# Work Order ID 89887

Item Name: Crosstube Turning Detail

DRAWING NO. D407-667-145	TITLE CROSSTUBE ASS'Y (407 HIGH FWD)	REV. C	<b>DART AEROSPACE LTD ENGINEERING ORDER</b>		D.E.O. NO. D407-667-145-C-1	SHEET NO. SHEET 1 OF 1	SCALE NTS
DRAWN <i>q</i>	CHECKED <i>ASS</i>	MFG. APPR. <i>IB</i>	APPROVED <i>WD</i>		DE APPR. <i>HA</i>		
DATE 11.07.15	DATE 11.07.22	DATE 11.07.22	DATE 11/07/22		DATE 11.07.21

DRAWING NO. D407-667-145	TITLE CROSSTUBE ASS'Y (407 HIGH FWD)	REV. C	DART AEROSPACE LTD ENGINEERING ORDER		D.E.O. NO. D407-667-145-C-2	SHEET NO. SHEET 1 OF 1	SCALE NTS
DRAWN AJS	CHECKED	MFG. APPR.	APPROVED		DE APPR.		
DATE 12.08.02	DATE 12.08.02	DATE 12.08.02	DATE 12.08.02		DATE 12.08.02

**DETAIL P**  
BONDING STRAP INSTALLATION 2 PL

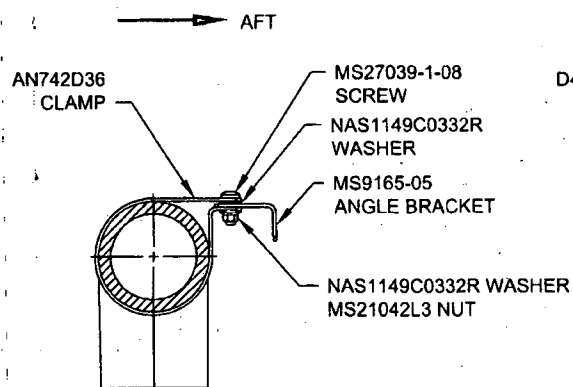
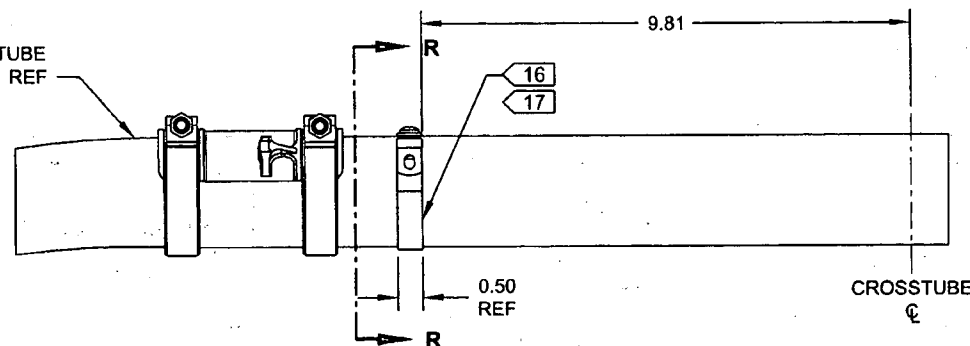
ADD ELECTRICAL GROUNDING STRAP

ITEM	QTY -145	PART NUMBER	DESCRIPTION
1	X	D407-667-145	CROSSTUBE ASSEMBLY (407 HIGH FWD)
10	2	AN742D36	CLAMP
11	2	MS9165-05	ANGLE BRACKET
12	2	MS21042L3	NUT (OR MS21042-3)
13	2	MS27039-1-08	SCREW
14	4	NAS1149C0332R	WASHER (OR AN960C10L)

- 16) MASK AREA UNDER CLAMP PRIOR TO PAINTING
- 17) SEAL EDGES WHERE AN742D36 CLAMP MEETS WITH THE CROSSTUBE USING SIKAFLEX-241/-291 OR MIL-S-8802 CLASS B2 OR PROSEAL 890 SEALANT
- 18) PERFORM RESISTANCE CHECK TO ENSURE MAX RESISTANCE IS 10 MILLIOHMS
